E-flite Beechcraft D18 Manual Addendum Instructions

Elevator Control Surface Centering Update

EFL106250, EFL106275

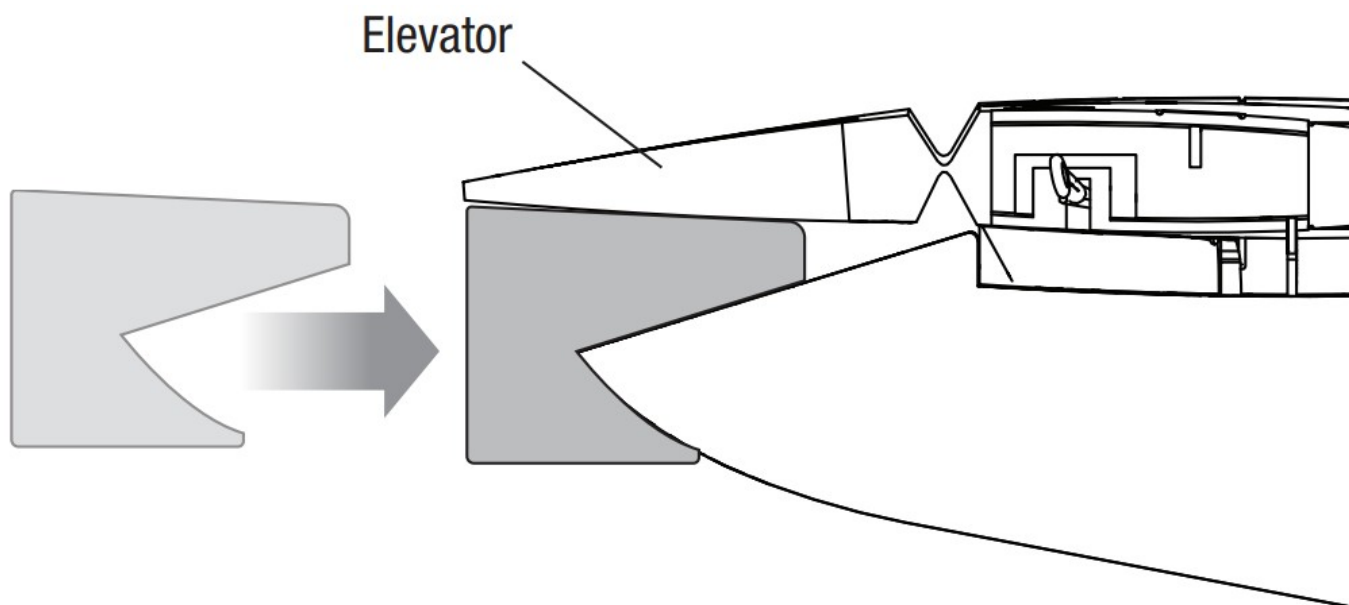
For level flight, with the recommended battery, the elevator will be deflected down a small amount. Use the included gauge to set the neutral position.

To verify the neutral position of the elevator, set the gauge in position at the end of the fuselage as shown. Align the top edge of the gauge with the bottom of the elevator. If necessary, adjust the elevator clevis to achieve this position.
